FINAL DRAINAGE REPORT for

Legacy Church
10460 W Hwy 24,
Green Mountain Falls, CO

PCD File No. PPR1933

Prepared: July 19, 2019
Resubmitted: September 17, 2019

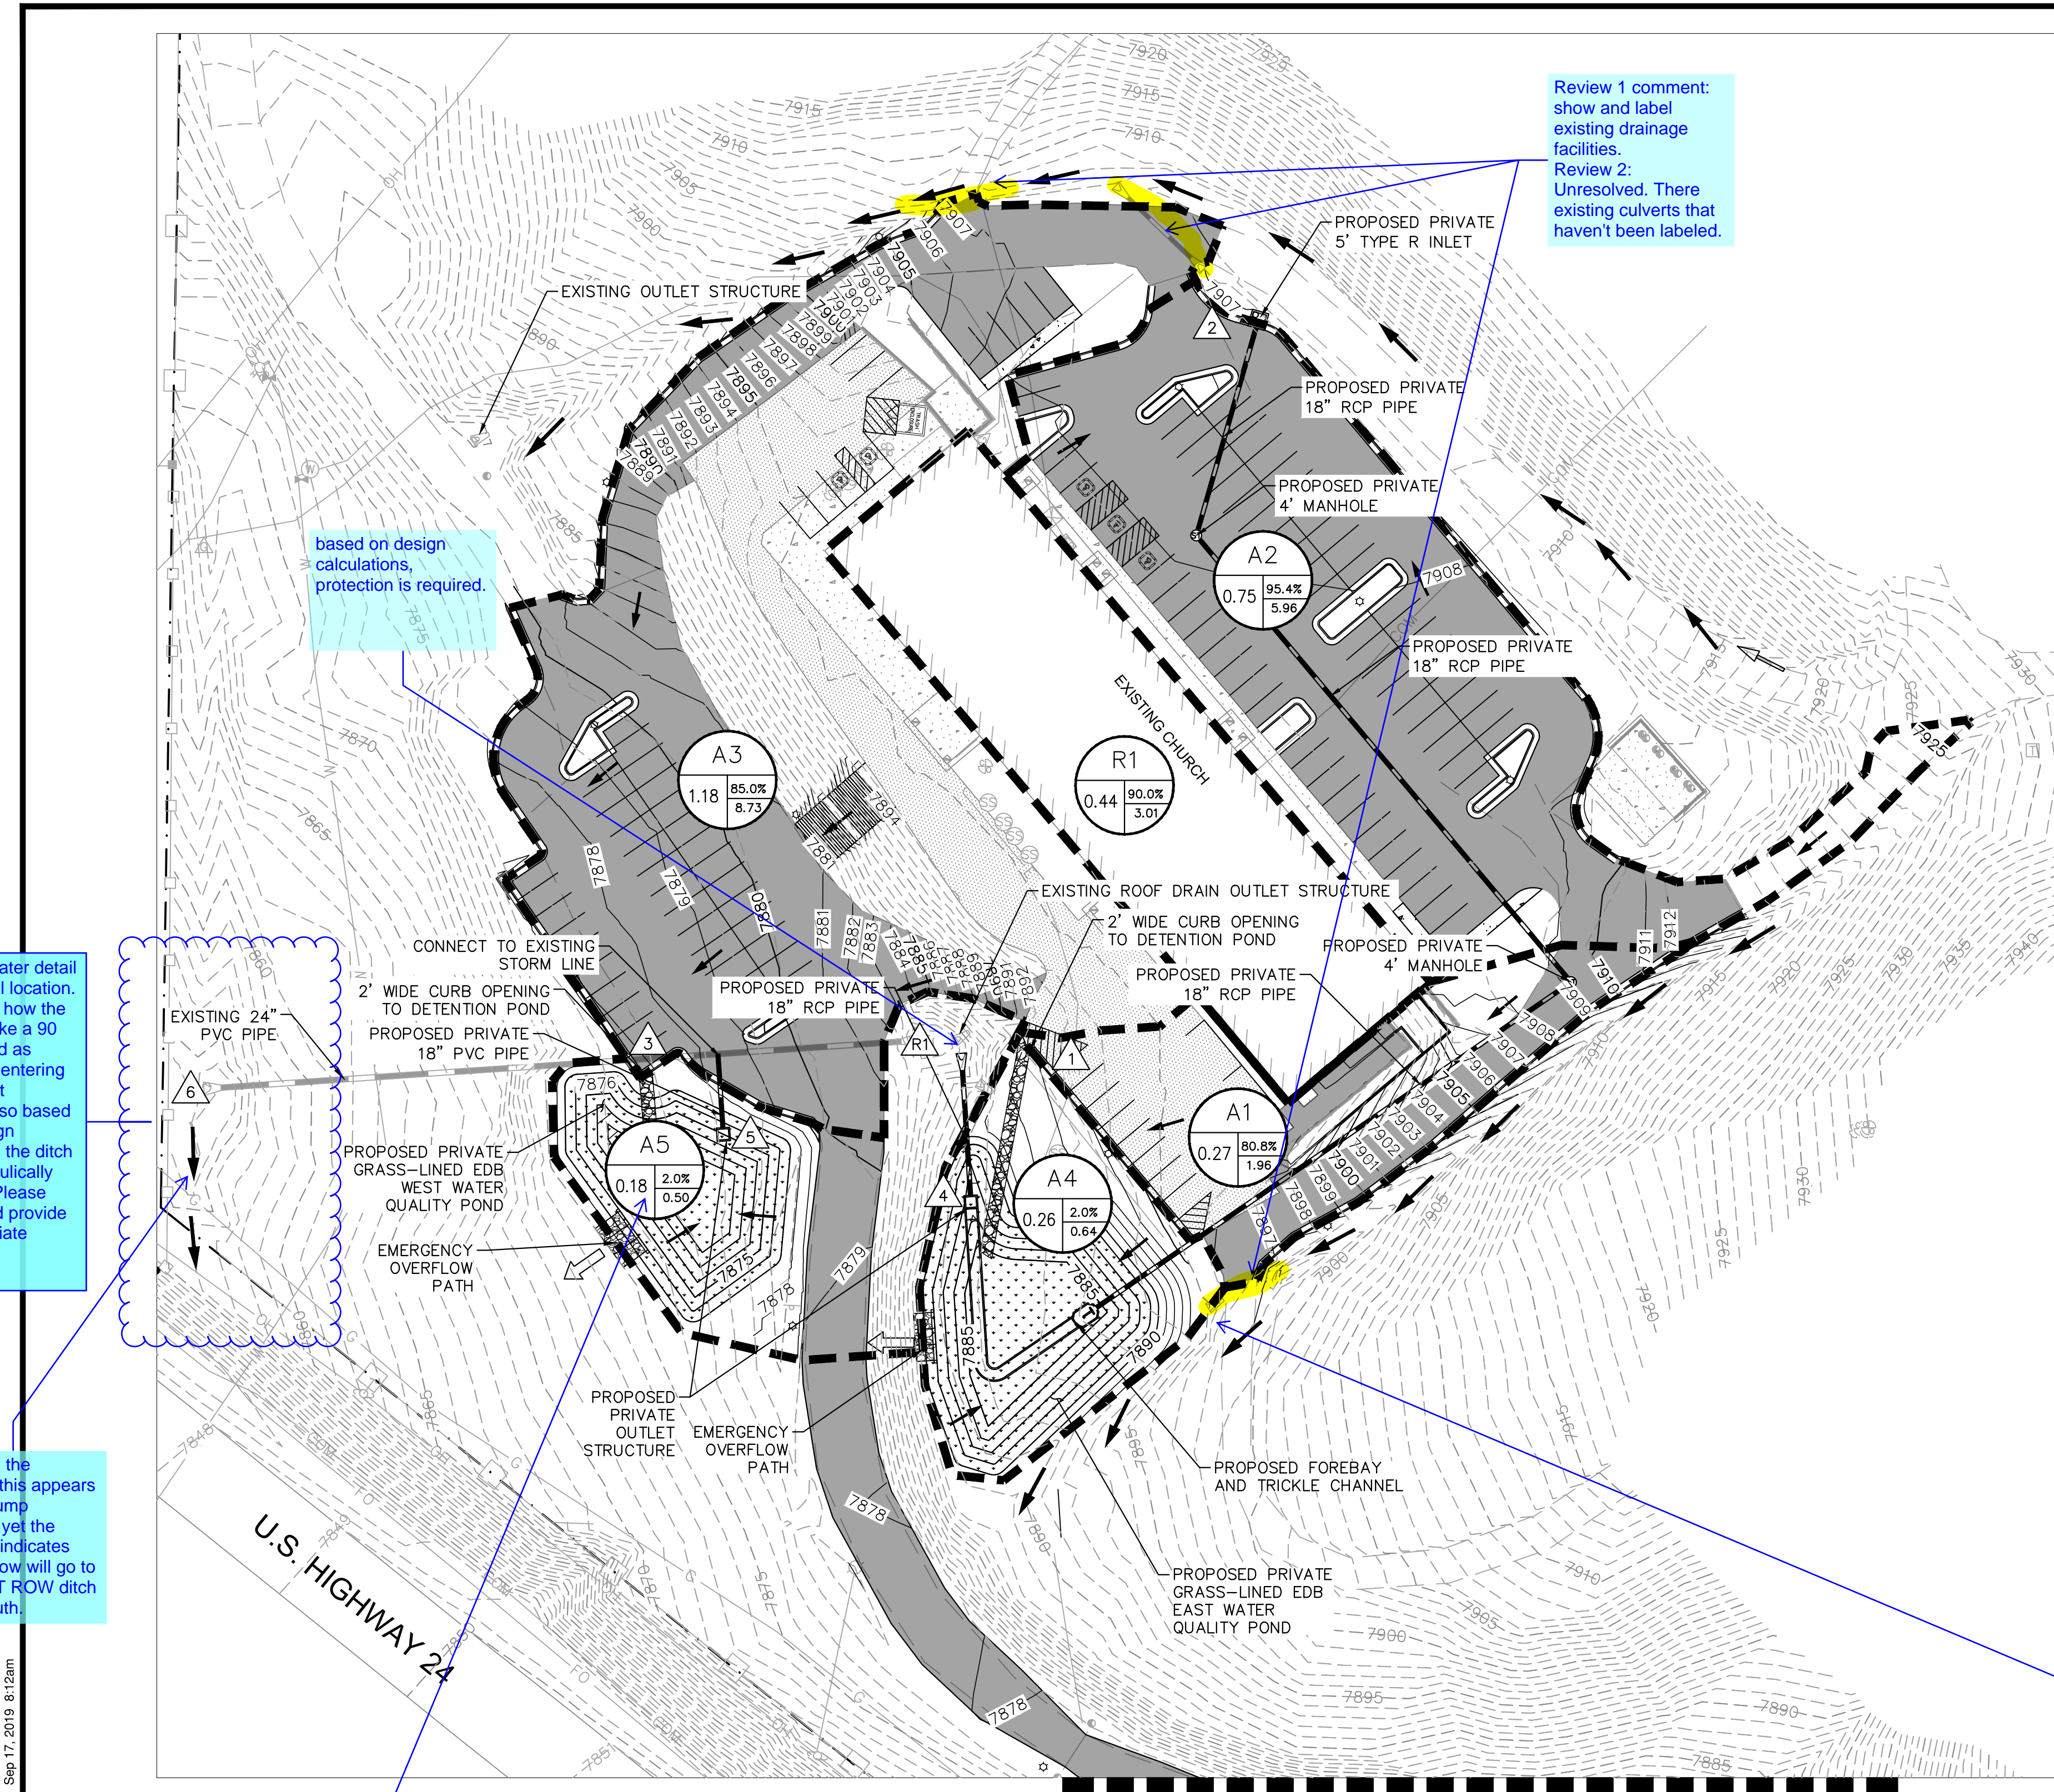
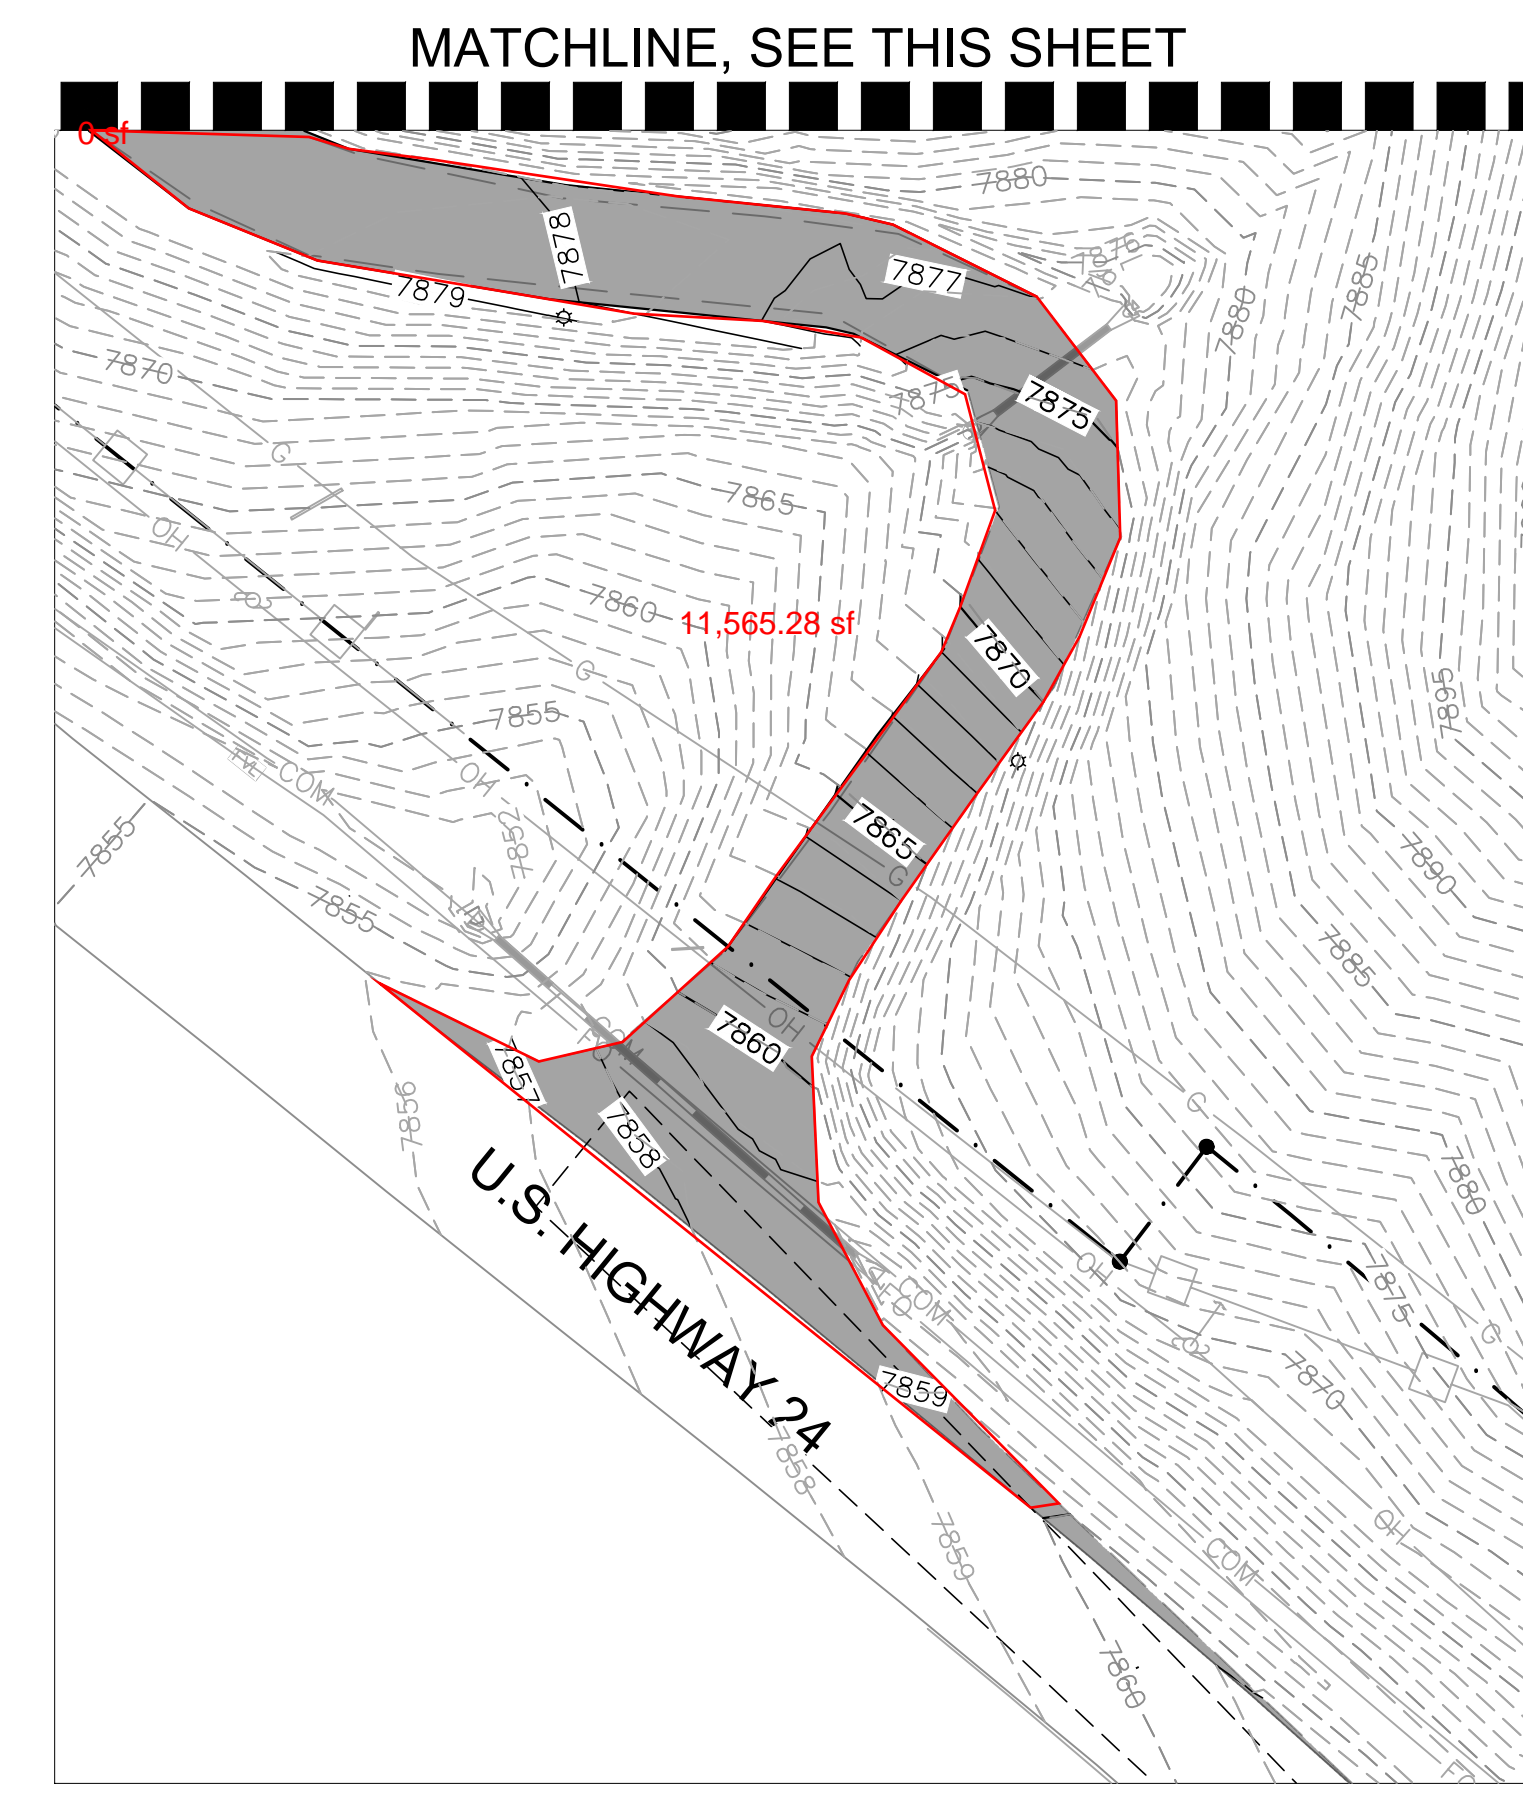
Review 1 comment: show and label existing drainage facilities.
 Review 2: Unresolved. There existing culverts that haven't been labeled.

Provide greater detail at the outfall location. It is unclear how the flow will make a 90 degree bend as opposed to entering the adjacent property. Also based on the design calculations the ditch is not hydraulically adequate. Please analyze and provide the appropriate protection.

Construction plans and details for the detention ponds have not been provided on the GEC plans for review. Please provide.

Review 1 comment: It appears that areas/sub-basins outside of the proposed development area are also tributary to the proposed ponds. The ponds should be designed accordingly for all flows even those outside the development area.
 Review 2: unresolved. The flow from the culvert shown is directed to the pond. Please account for this area that flow into the pond.

The proposed flow at the ultimate outfall shall be at or below historic. These flows are larger than what is shown on the existing drainage plan. Please revise.
